# Muller Plan as it affects the canal bridge and traffic flow through Audlem

**Muller plan which they added to CE Planning portal on the 26-3-2026**

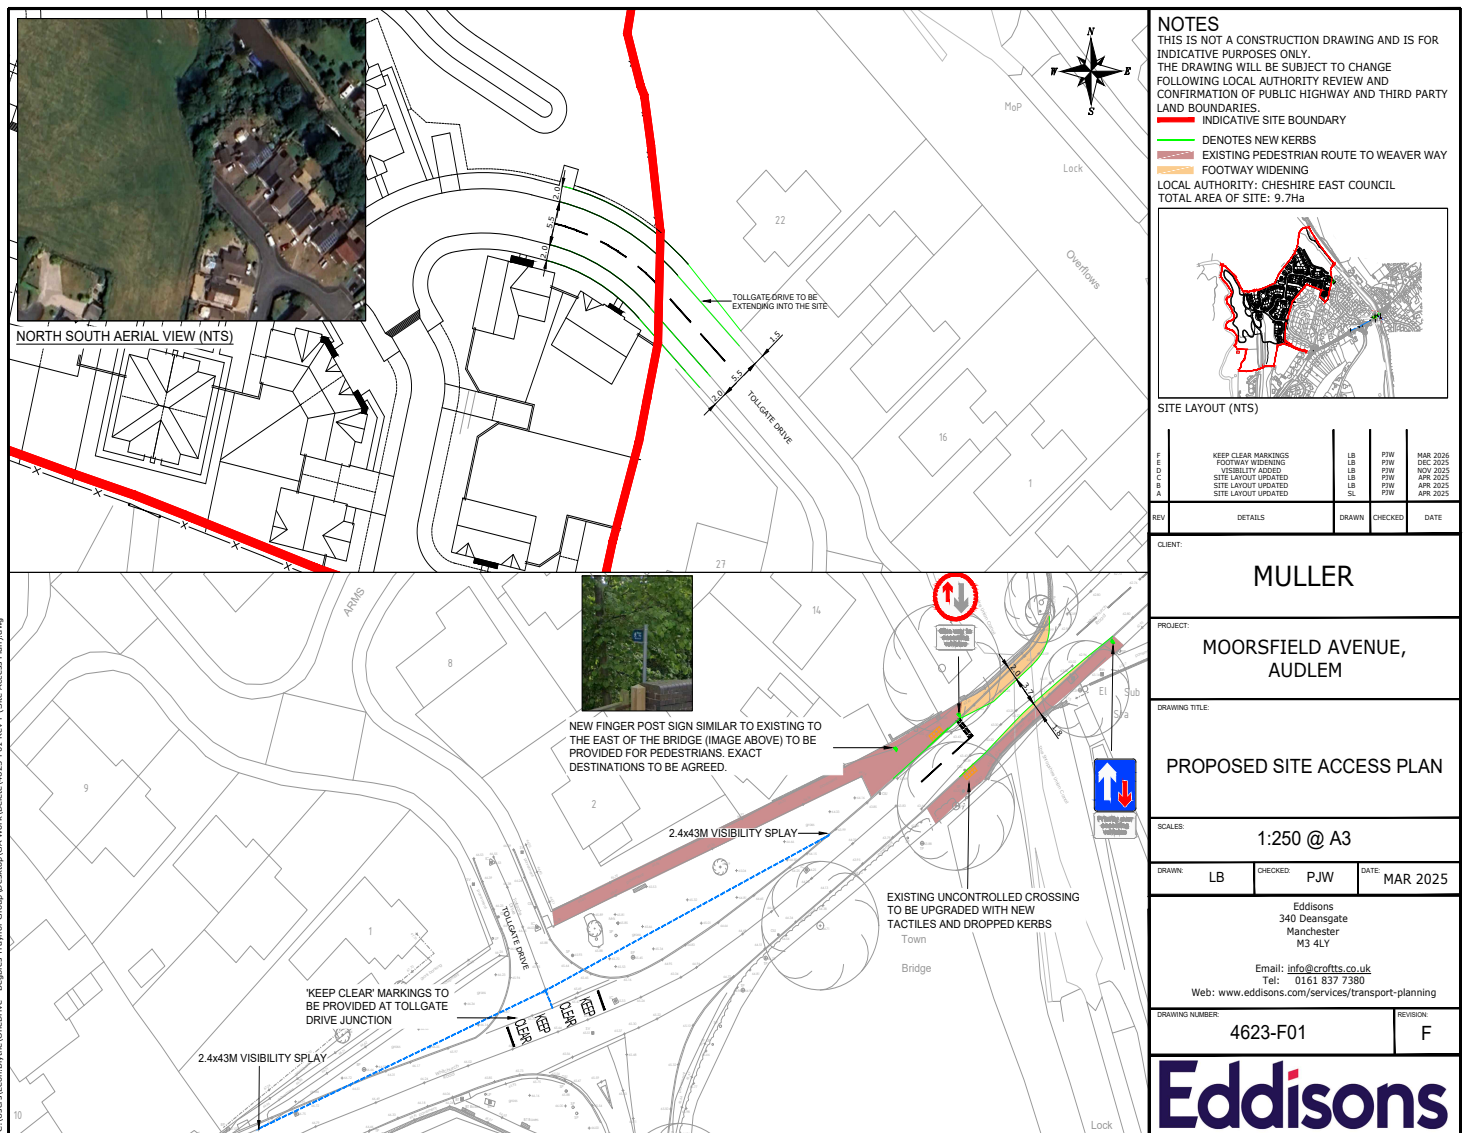
The existing footpath over the canal bridge coloured in pink.

The widened footpath on the Tollgate side of the bridge in beige. This enlarged footpath on the Tollgate Drive side of the road is increased from 0.5m to 2m, the footpath on the other side is 1.8m

This will be a proper footpath with a kerb edge rather than the white painted 'ghost type island' that already exists.

The road width will be reduced to 3.7 metres to allow single file traffic through. Note that the end of Tollgate Drive where it is planned to connect to the new development is 5.5m

There will be give way lines on the Whitchurch side of the bridge. In addition, at each end, signs instructing drivers that traffic approaching from the village will have priority over the bridge plus signs showing that traffic coming into the village from Whitchurch will need to give way!!!!

At the exit of Tollgate Drive and Green Lane on the A525 main Whitchurch Road there will be painted road markings saying 'Keep Clear'

Muller will replace the, perfectly good, existing drop kerb and tactile paving on the Whitchurch side of the canal bridge with similar drop kerb and tactile paving, (why?).

Muller also say that they will put a 'finger post' type sign, similar to the public right of way at the gate leading to the canal tow path, just visible on the plan, not sure what that's for!

1. Traffic may not observe the direction priority, this behaviour can be demonstrated by observing the current flow of traffic down Cheshire Street where the road width is reduced to single file, due to parked cars. It can also be seen with the reduced road width past the Coop and people parking on yellow lines to use the Coop. This traffic congestion is bad at times, it will only get worse if the canal bridge is made single file.

2. Traffic also queuing to enter the village from the Whitchurch direction will face further challenges on Saturdays when people are dropping off donations for the Charity Shop, only a few metres from the canal bridge. In addition Dray lorries delivering outside the Bridge Pub would hinder the 'queuing' system over the canal bridge.

3. The chaos will further be added to by people regularly turning round in the entrance to Windmill Drive having been to the Coop and then needing to head back through the village. In addition trying to get onto the main road from the street between the canal and Bridge Pub will be very difficult.

4. The plan shows the **reduced road width at only 3.7 meters**. A simple Google search shows Milk Tankers and HGV's being around 2.6m wide but with mirrors up to 3m wide (breathe in if your crossing the bridge!), Tractors at 2.55m, or 3m with a 20mph restriction and combine harvesters at 3m wide. With this narrow width HGV's and farm vehicles will, as can already be seen around the village, mount the kerb and potentially risk injury, or worse, to pedestrians.

5. Having put clear road markings on the main Whitchurch Road at it's junction with Tollgate Drive and Green Lane saying 'Keep Clear', traffic heading towards the canal bridge from the Whitchurch direction will start to queue back along what has already been identified as a narrow bottleneck / pinchpoint, between Tollgate and Mooresfield avenue. The traffic, with priority, coming out of Audlem will not be able to get past the queuing traffic at the pinch point and will, as regularly happens drive on the pavement to get through.
